NEWCOMBE ROAD SAND QUARRY: NOISE PEER REVIEW

Marshall Day Acoustics has been engaged by Waipa District Council in a review capacity to assist with the processing of a land use consent application (LU/0077/23) for a new sand quarry to be located near Cambridge.

Figure 1: Excerpt of Figure 10 from Hegley report

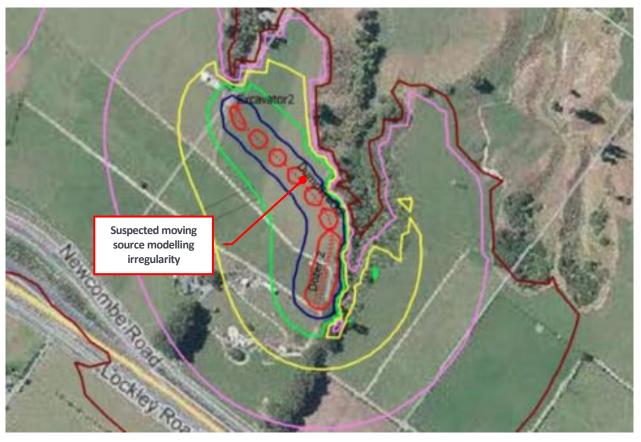
With respect to the noise contour calculations displayed in Figures 10 to 12, specifically some of the moving sources, we suspect that the lines used to define the routes of the mobile machinery do not follow the terrain 100% of the time (as indicated in Figure 1 overleaf) this can lead to underprediction of noise levels in some instances when part of the line source dips below the terrain. Can Hegley confirm whether all modelled moving sources follow the terrain. If they do not, we ask that Hegley comment on how this will affect calculated levels at all identified receivers. The re generation of noise contours may be required.
